**ADA TOWNSHIP PLANNING COMMISSION  
THURSDAY, MARCH 16, 2017 MEETING, 7:00 PM  
TOWNSHIP OFFICES, 7330 THORNAPPLE RIVER DR.  
ADA, MICHIGAN**

## MEMORANDUM

**TO:** Ada Township Planning Commission  
**FROM:** Brent M. Bajdek, Planner/Zoning Administrator  
**RE:** March 16, 2017 Agenda Items

**1. PVM Development Plan Review, 2,411 Square Foot Building Addition, 7144 Headley St. SE, Parcel No. 41-15-33-228-013, Ada Historical Society**

**Averill Museum Addition**  
7144 Headley Street SE  
Ada, Michigan  
**Site Plan**

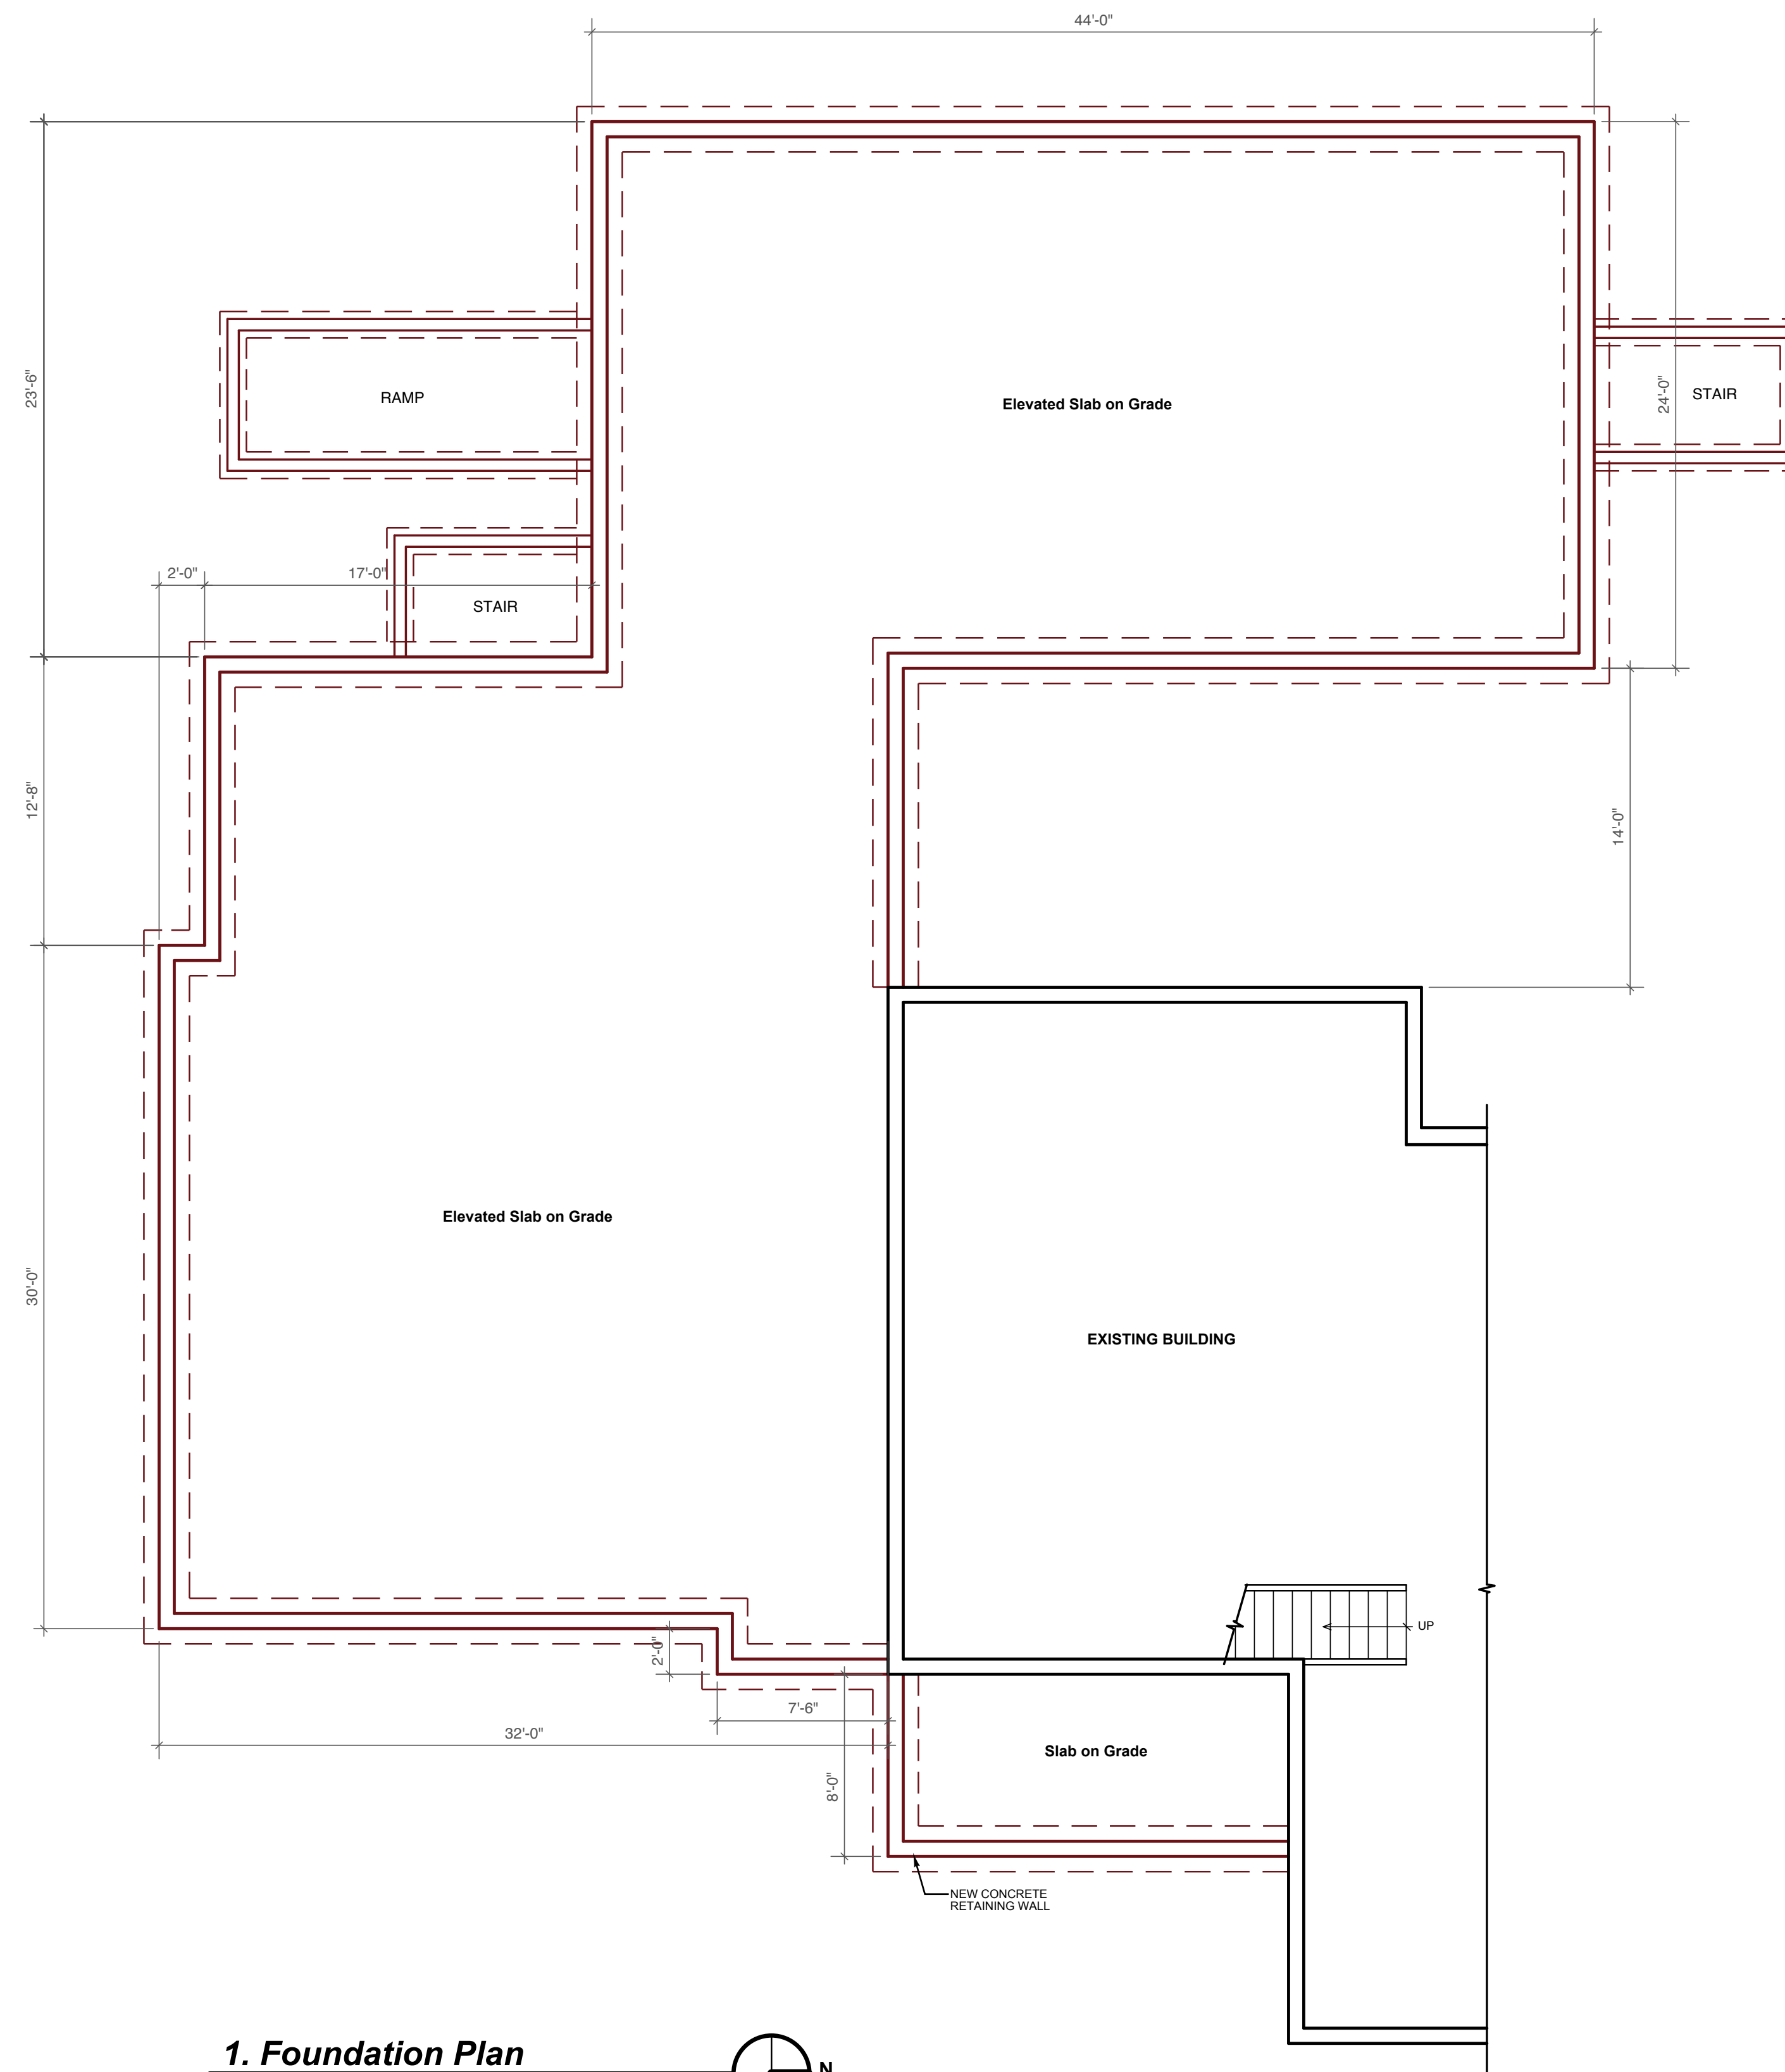
An expansion of the existing building to the west and south is planned. A one-way traffic circulation route exists, with ingress from Headley Street, exiting on to Teeple Avenue.

Parking:

The Zoning Ordinance requires one (1) parking space per 200 square feet of floor area for ‘libraries, museums, and governmental administration buildings.’

The PVM district standards allow for reduction in parking required to 80% of the normal requirement for Public and Civic Uses in the Village Proper 2 Transect Zone, to take into consideration availability of nearby parking, as well as reduction in demand due to offsetting demand peaks of mixed uses in the surrounding area.

Based on museum parking requirements for the existing building and proposed addition, 11 parking spaces are required (*nine (9) parking spaces with reduction*). *Seven (7) parking spaces are currently provided onsite; no additional parking spaces are proposed to be constructed in conjunction with the proposed addition. (It should be noted that the square footages of the second story (storage area), the*

*Per 78-788(4) of the Zoning Ordinance, the Planning Commission may permit required parking to be deferred if the parking space requirements would result in an excessive number of unneeded spaces for a proposed use. A deferral of four (4) parking spaces (two (2) parking spaces with reduction) is proposed. Although the parking spaces have not been identified on the development, ample room is available onsite for their construction; however, it appears that mature trees would have to be removed to allow for such construction.*

A number of mature trees exist onsite; no new landscaping is proposed. It appears that one (1) existing tree will need to be removed to accommodate the proposed addition.

Approval of the development plan, including the deferral of construction of four (4) parking spaces (two (2) parking spaces with reduction) is recommended, subject to the following condition:

- Exterior building mounted light fixtures shall qualify as “full-cutoff” control of light emission or of a low light intensity non-glaring style, subject to approval of the Planning Department. Fixture specifications shall be submitted for approval, prior to building permit issuance.
- 2. PUD Pre-Application Conference, Attached Townhomes (74 Units in 17 Buildings) on a 9.9 Acre Site, 1040, 1050, 1078, and 1090 Spaulding Ave. SE, Parcel Nos. 41-15-31-451-017, 008, 009 and 010, John Wheeler and Michael Maier**

1040, 1050, 1078, and 1090 SPAULDING AVENUE SE  
PLANNED UNIT DEVELOPMENT PRE-APPLICATION

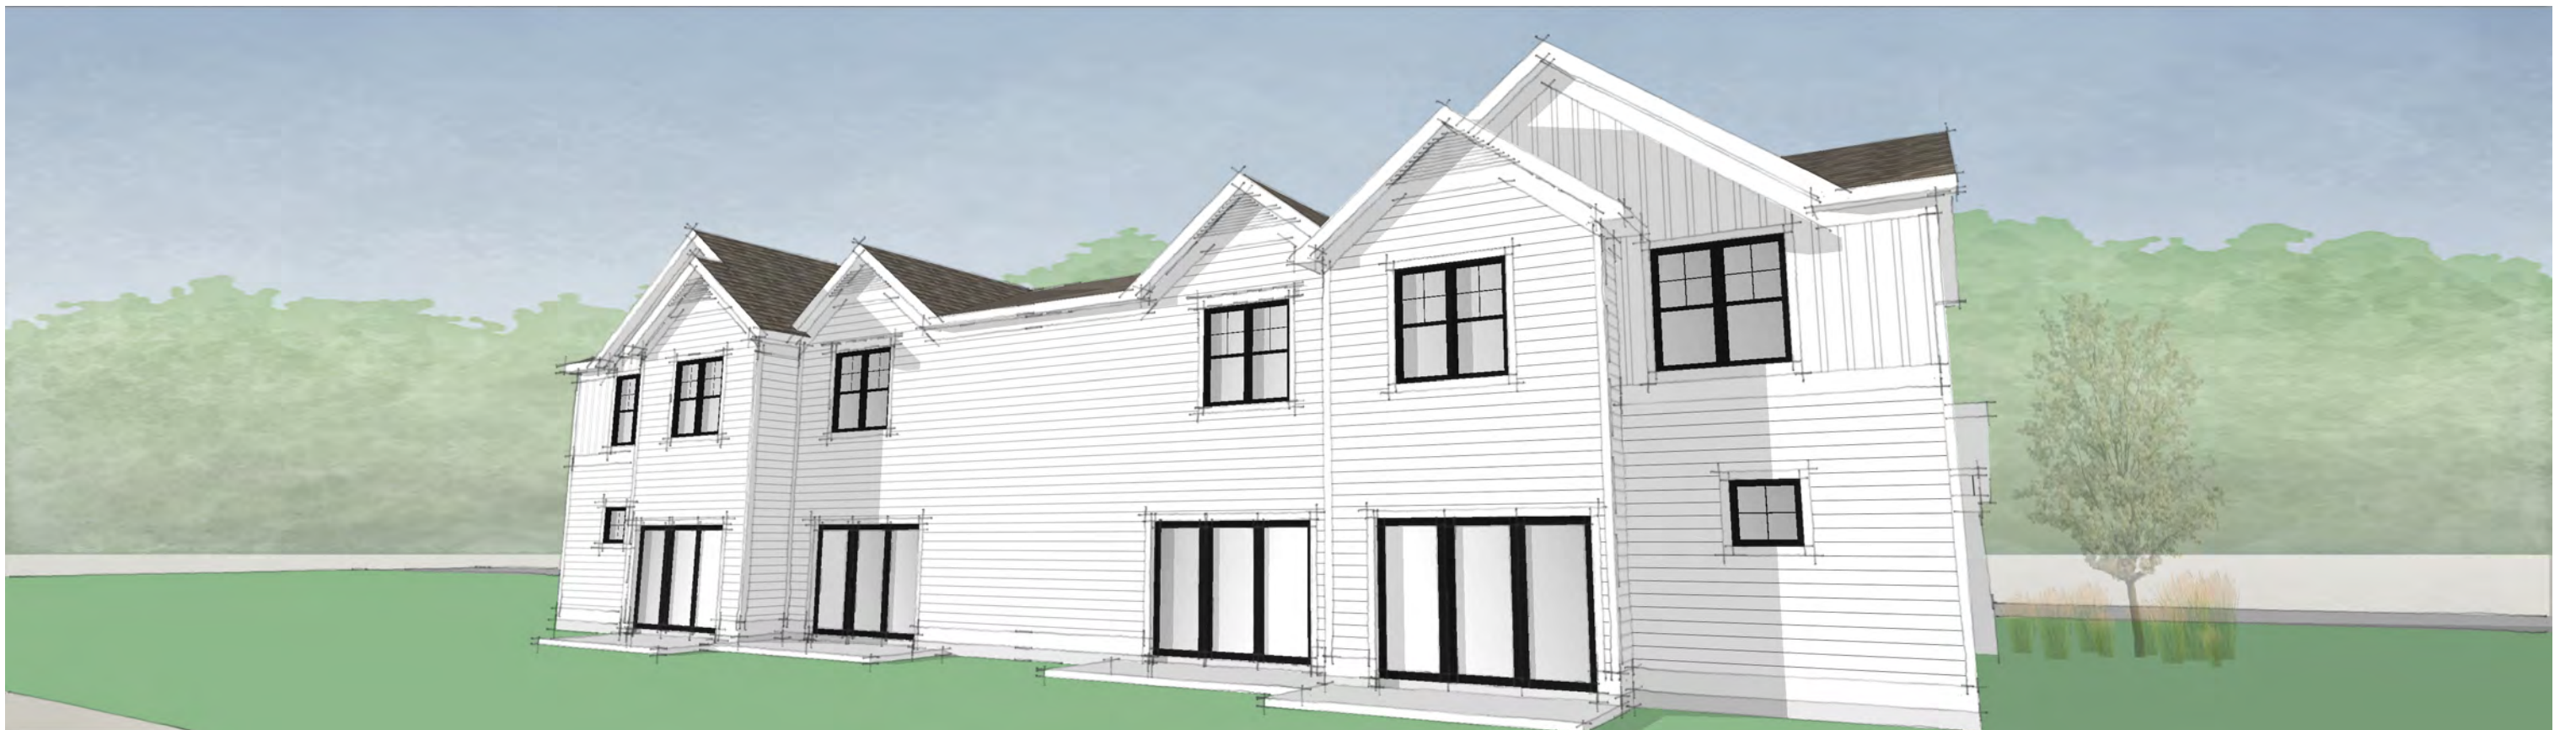
- The proposed density of the site is calculated to be approximately 8.79 units per acre with the assumption of 15 percent of the gross land area being devoted to rights-of-way. *(Per Sec. 78-449 of the Zoning Ordinance, in residential PUDs where the amount of land to be included in public or private street rights-of-way is not known with certainty at the time of preliminary development plan approval, allowable maximum gross density shall be determined based on 15 percent of the gross land area being devoted to rights-of-way.)*

The intended density of the site is in accordance with the recently approved amendment to the Master Plan that allowed for the densities of the “Medium Density Residential” land use category of the Future Land Use map to increase from up to a maximum density of six (6) units per acre to nine (9) units per acre. However, the subject site consists of properties zoned PO Professional and R-2 Single-Family Residential. Property zoned R-2 Single-Family Residential under the PUD provisions of the Zoning Ordinance only allows up to a maximum density of six (6) units per acre.

- Two (2) access points to the development from Spaulding Avenue is proposed. A looped internal private drive/road has been designed to align with existing curb cuts on the west side of Spaulding Avenue for traffic safety.
- An expansive permanently-preserved wetland/open space is located at the northeastern extent of the site and extends northward; other wetland areas also exist onsite. The site has been designed to conform to the Township’s Riparian Area Protection Standards; “natural vegetation zones” and “transition zones” are indicated on the concept plan.
- The site is planned to be served with public utilities from Spaulding Avenue; the applicant has sought preliminary coordination for the connection.

The subject site is isolated from existing residential neighborhoods to the north and east by the wide power line corridor to the east, and the permanently-preserved wetland/open space area to the north. The proposed use of the property as a townhome development is in accordance with the 2016 Township Master Plan amendments.

Feedback and direction to the applicant from the Planning Commission is requested.
